## PLANNING COMMISSION MEETING

**RE: Ginko Self Storage -Final Site Plan/Final Engineering Plan Review-3<sup>rd</sup> Review  
Stormwater Maintenance Agreement Review-1<sup>st</sup> Review**

## Revised Final Site Plan Review for Special Land Use for White Lake Charter Township, Michigan

# GINKO SELF STORAGE

C-7.0

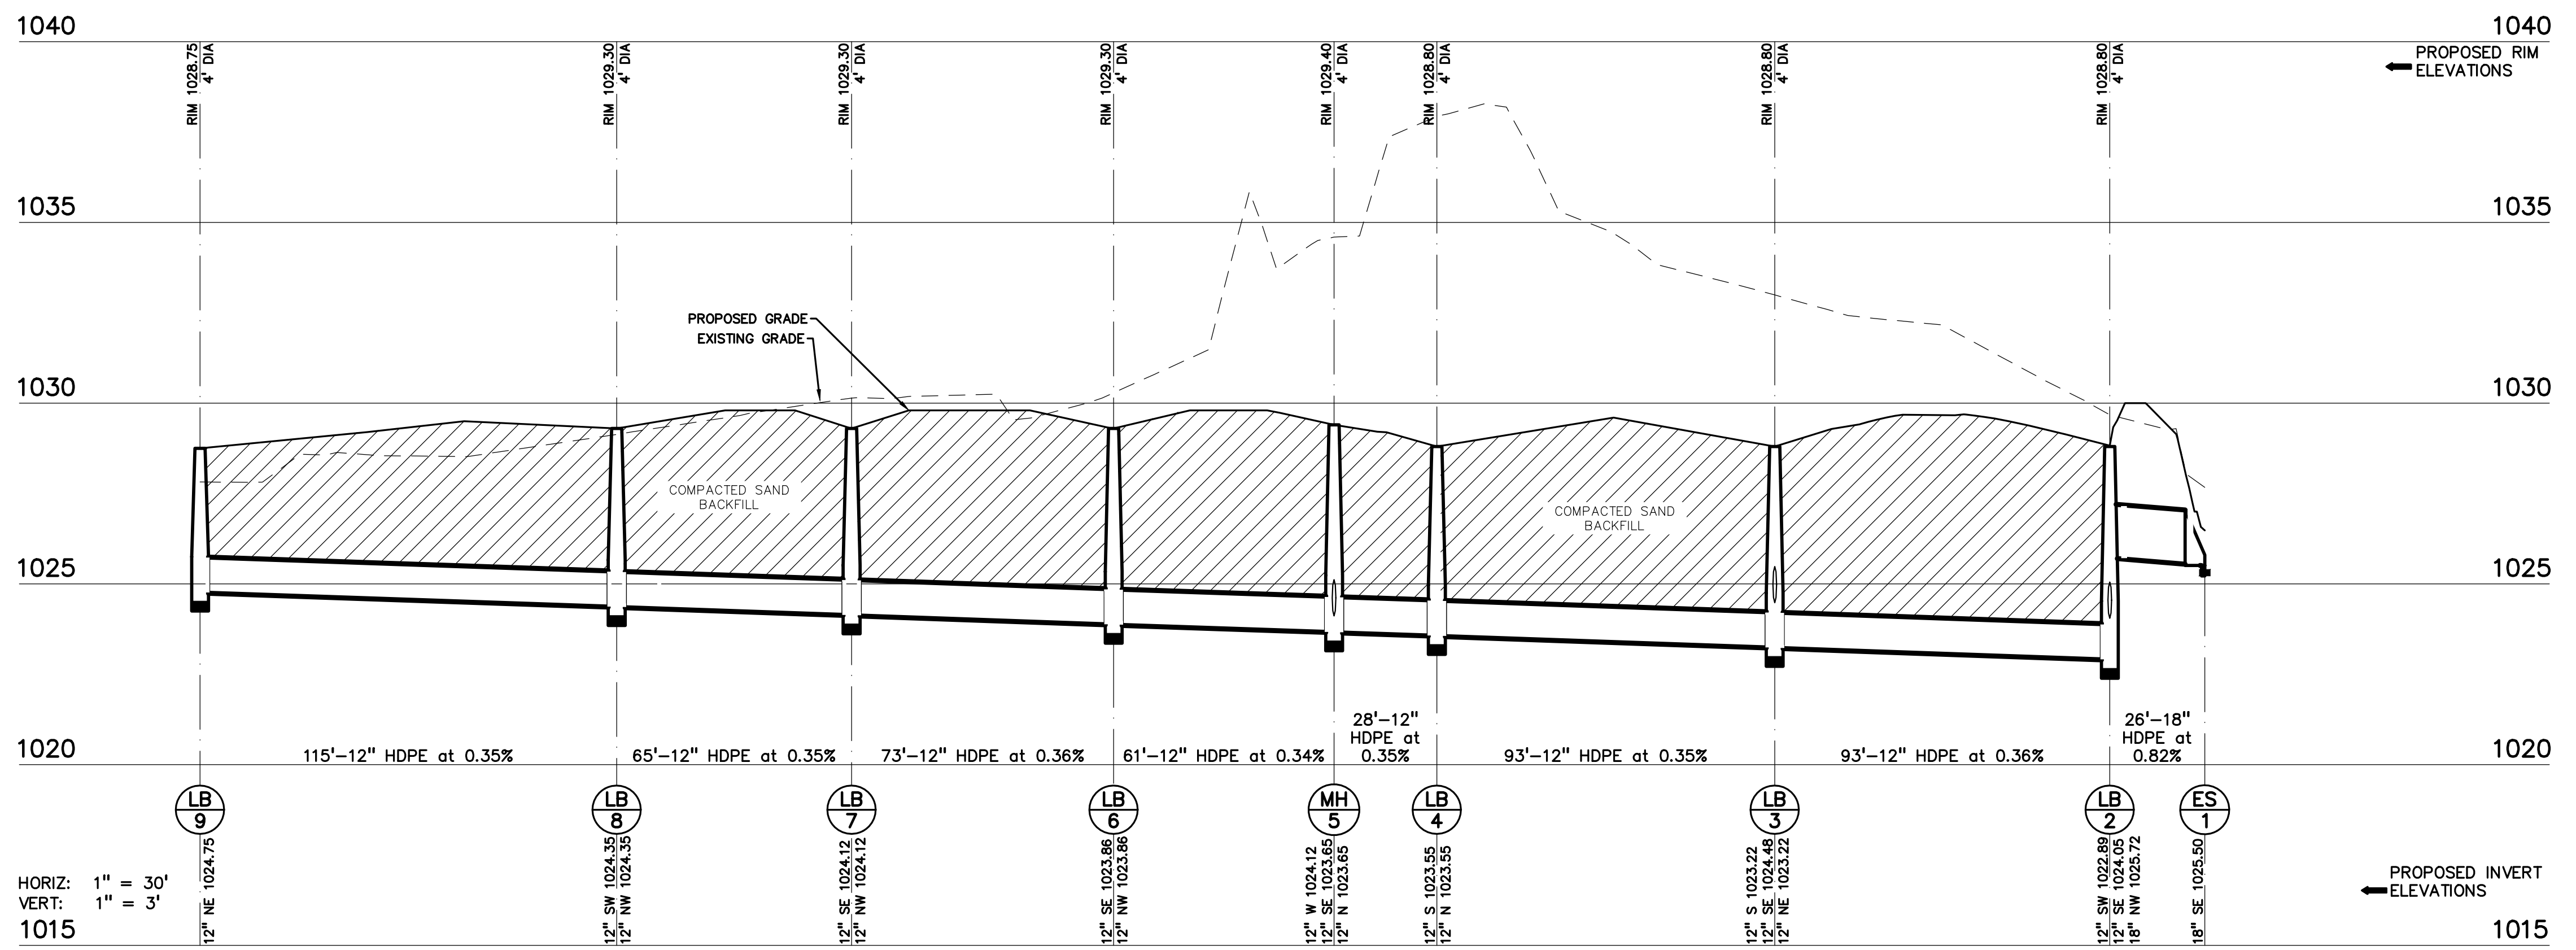
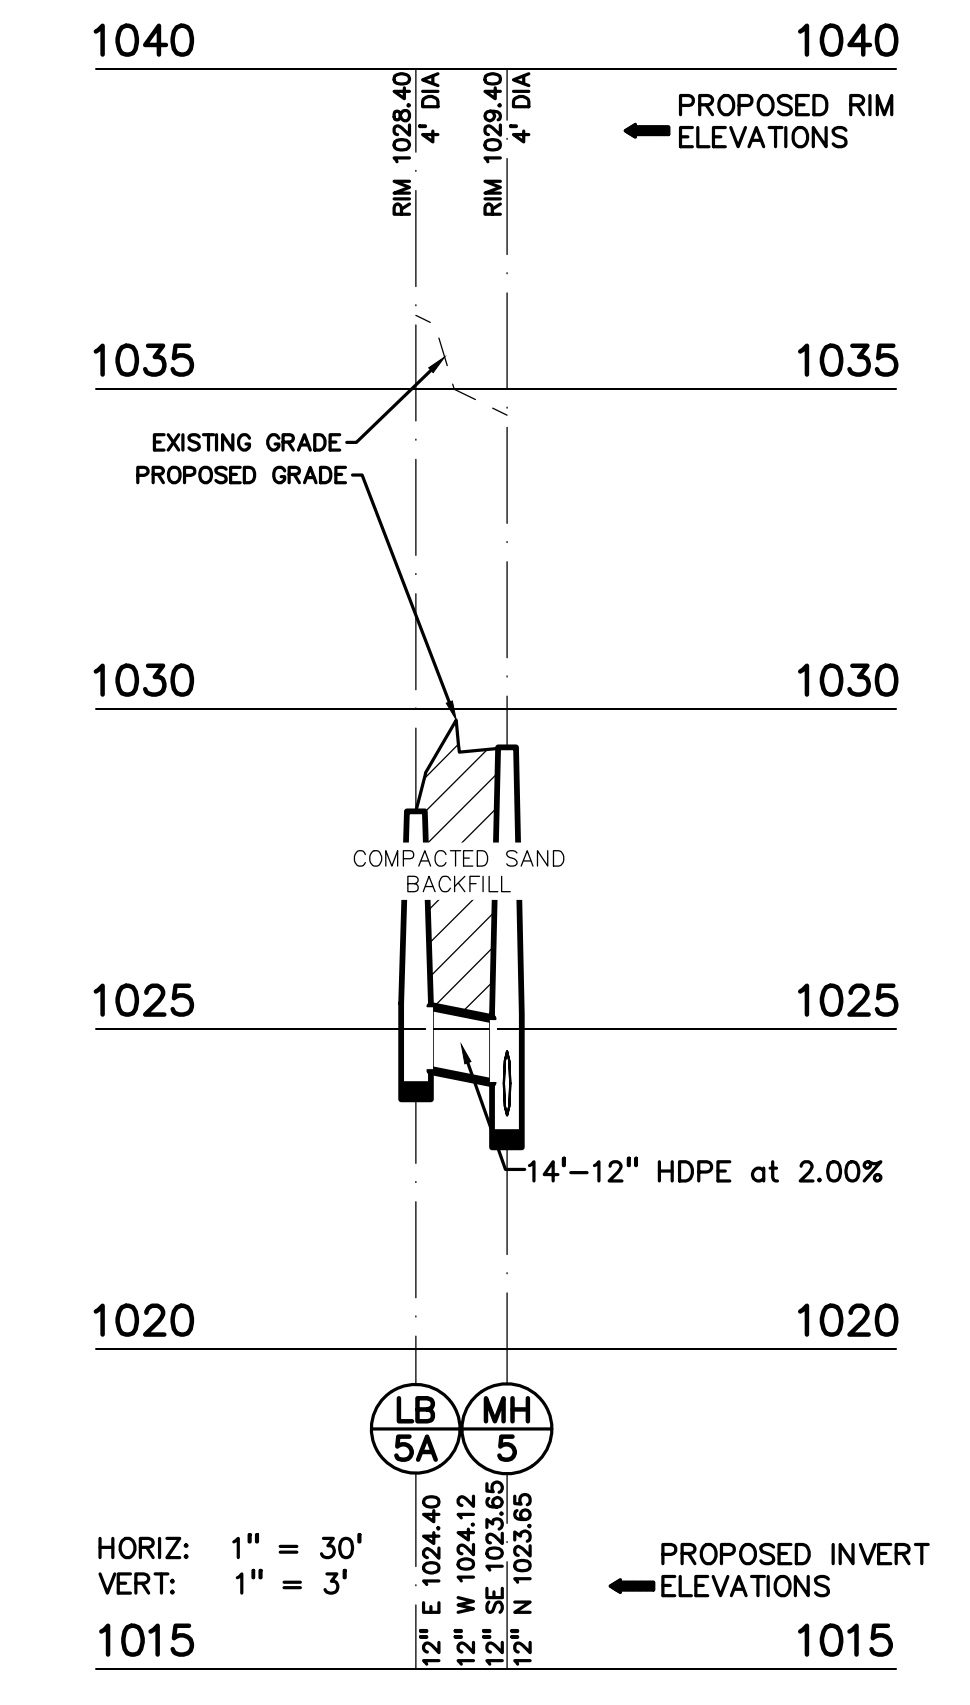
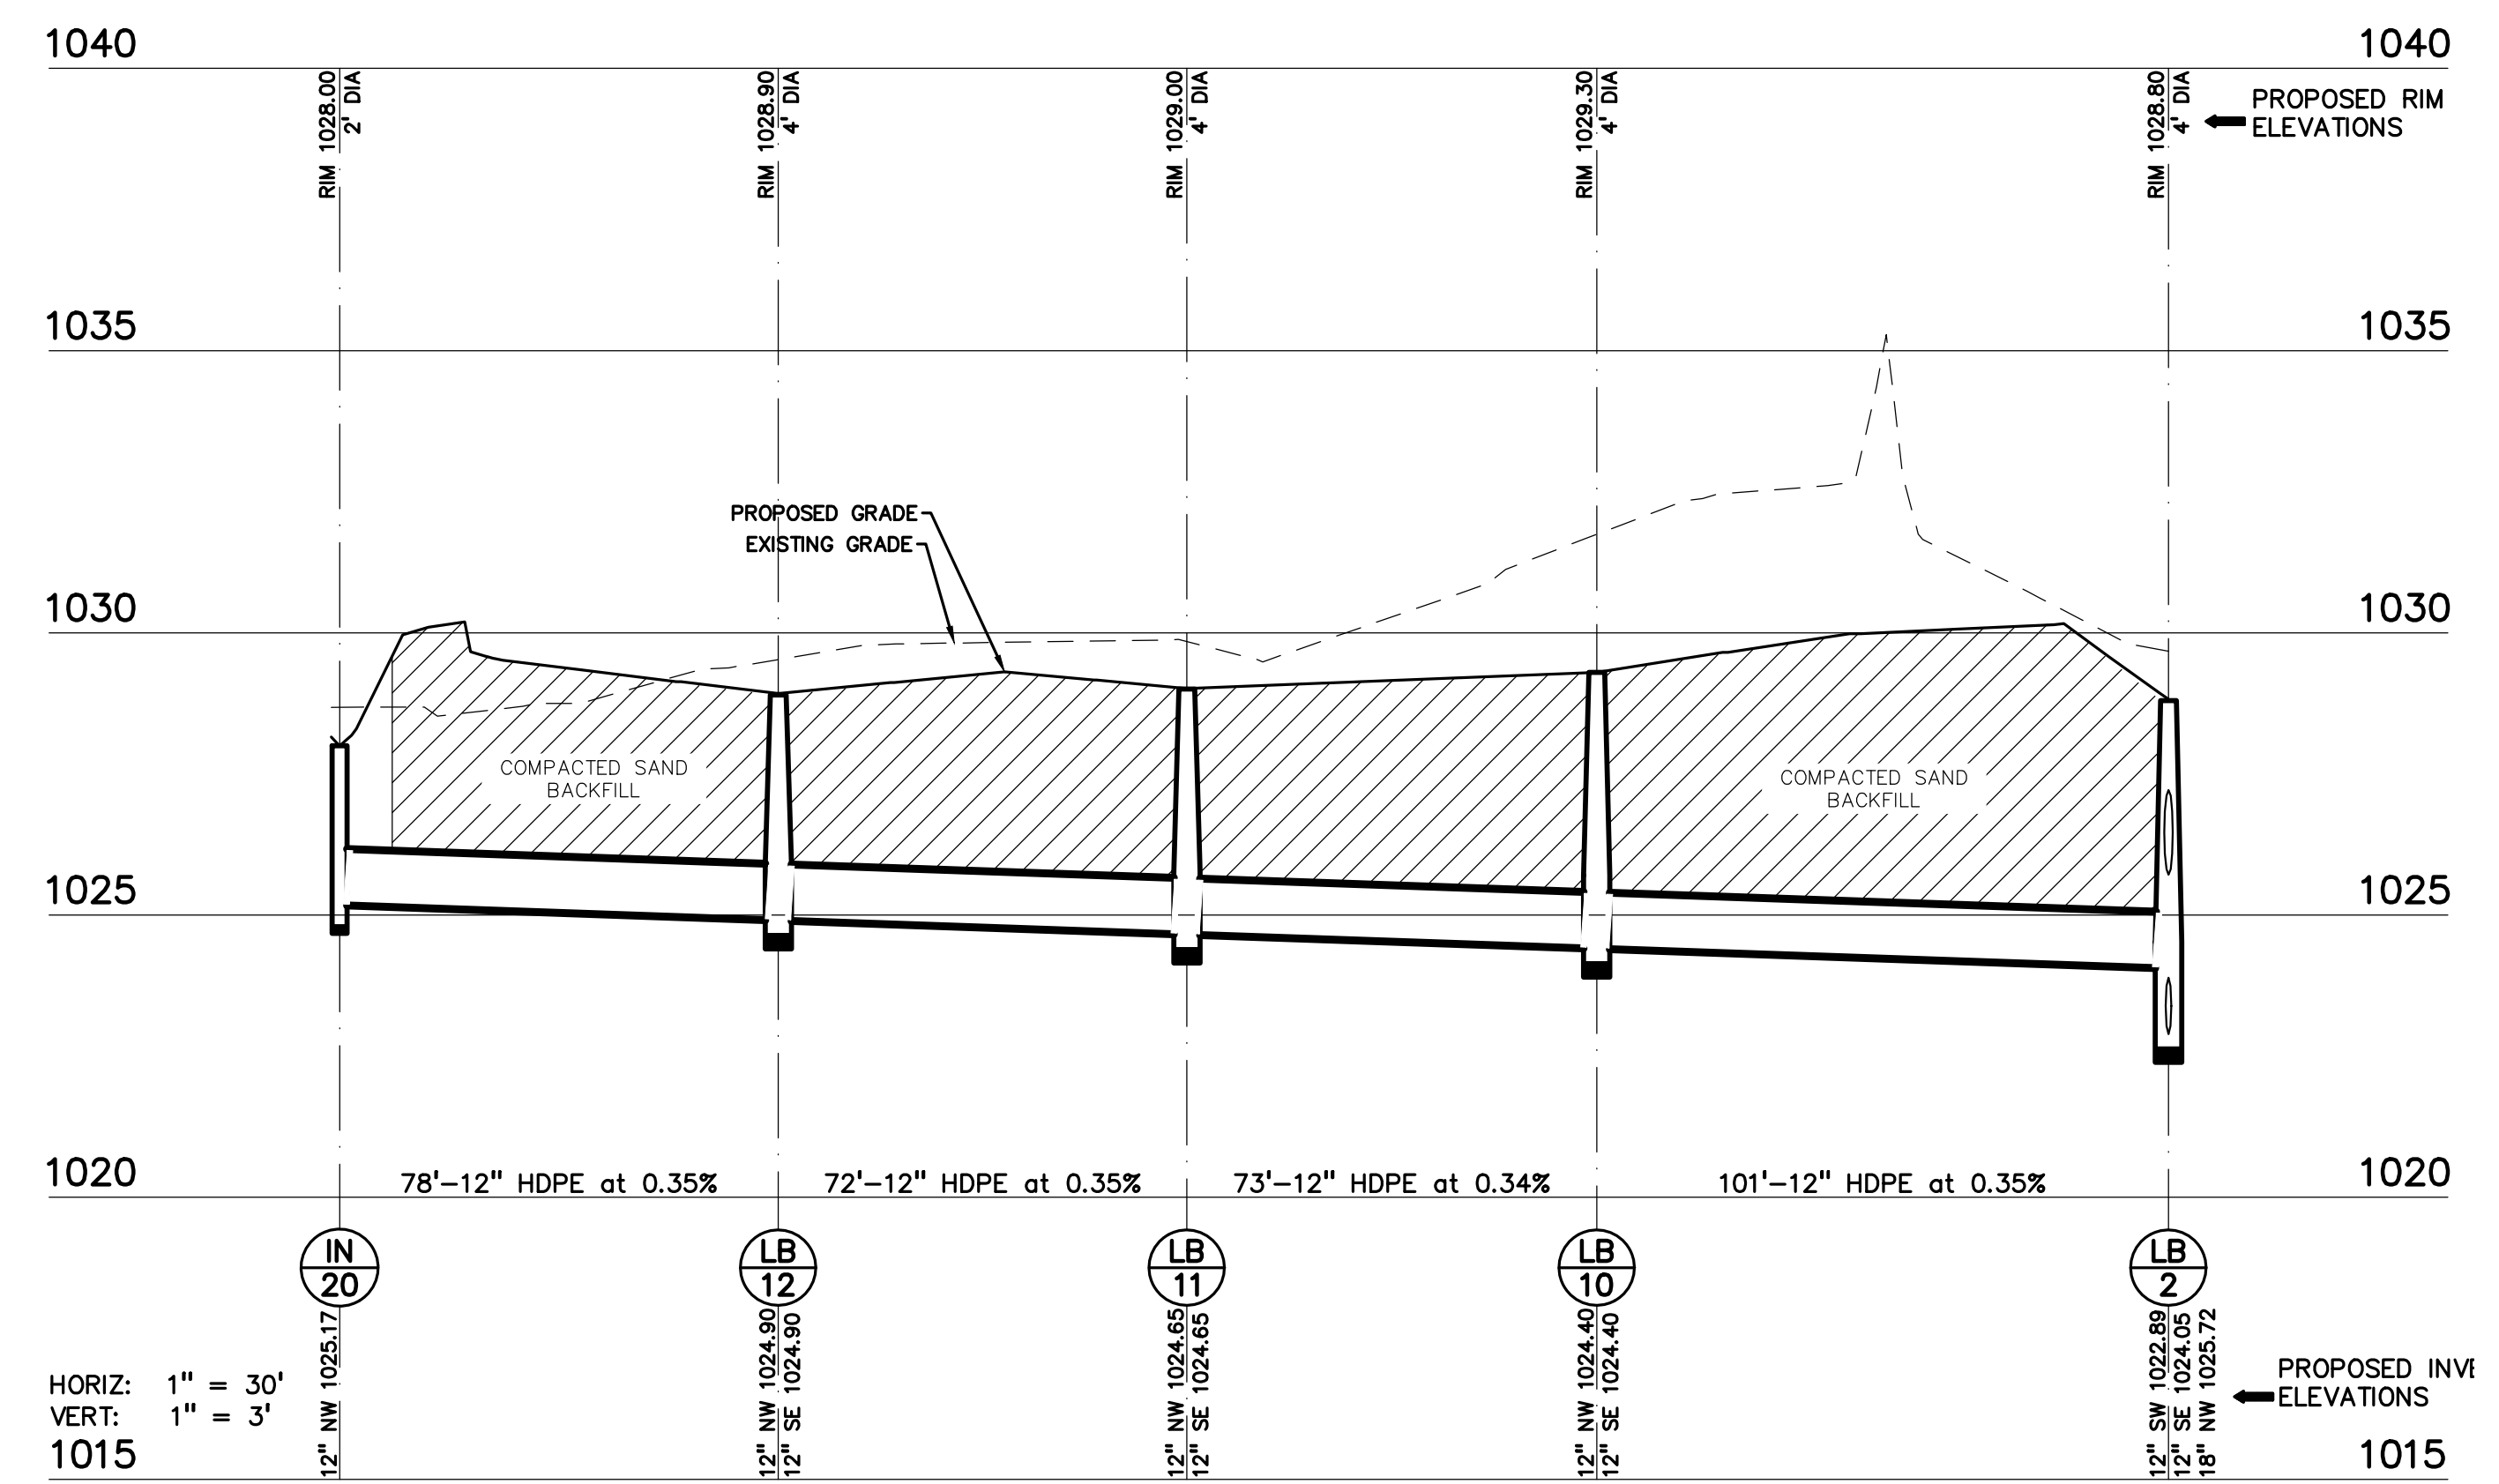
2. *Sheet C-7.0- The following pipe segments do not match Sheet C-6.0 in terms of footage, slope, or both. Please revise: 1) ES1-LB2; 2) LB4-MH5; 3) MH5-LB6; 4) LB6-LB7; 5) LB8-LB9; 6) LB2-LB10; 7) LB10-LB11; 8) LB11-LB12; 9) MH5-LB17; 10) LB13-LB14; 11) LB14-LB15. Comment partially addressed. Footages and slopes have been adjusted and now match with the exception of LB2-ES1. **Comment partially addressed. LB2-ES1 footage and slope now match; however, it now appears that the footage for LB3-LB-2 was adjusted and now does not match between Sheets C-6.0 and C-7.0.***
